# Feedback on the proposed Changes to River valley Park

Version 1.0

Rivervalley  
Tuesday 9<sup>th</sup> May 2023  
By Kevin Egan  
howtocompany.xyz

### Timeline

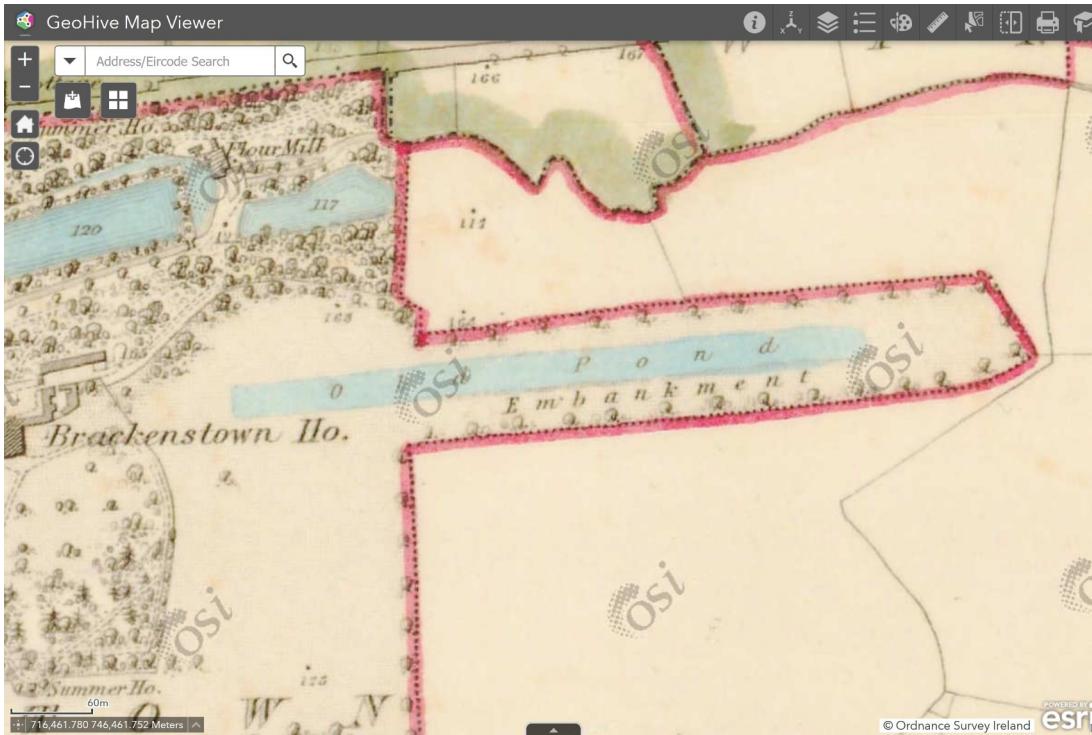
1717 Canal is built (~300 years ago)

1837 Canal is labelled 'Old Pond' (~180 years ago)

1908 Canal resembles current 2023 structure (~115 years ago)

120 Years after the canal was built, the map from 1837, Labels the Canal labelled as 'Old Pond'  
 This suggests that perhaps the "ingenious technical feat of 18th Century engineering and design" may have already began its neglect and degradation.

Around 115 years ago show the map shows the Canal as degraded to something resembling its current shape. The canal is shown as a wet area to the East and a marsh to the West end.
